# PINNACLE SITE PLAN REVISION PC 25-10 AND BOT 25-01

- **STAFF PRESENTATION**
- **AUGUST 21, 2025**

# PINNACLE AT MEYERS

- I308-1330 S. Meyers Road
- **3.9** acres
- Zoning: R2 Single-Family Residence District
- Comp Plan: Low Density Residential

#### APPROVED & REVISED PLANS

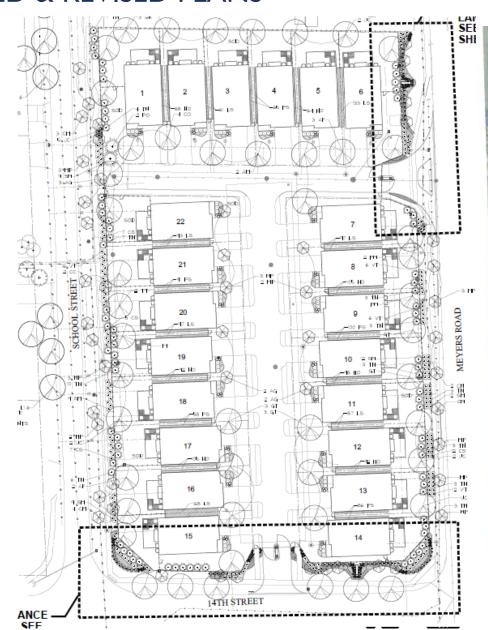
# WHAT IS CHANGING IN THE REVISED PLAN?

- Reduced unit count: 11 houses vs 22 houses
- Reduced density: 2.8 DU/acre vs 5.6 DU/acre
- Increased distance between houses: 12+ feet vs 6 feet
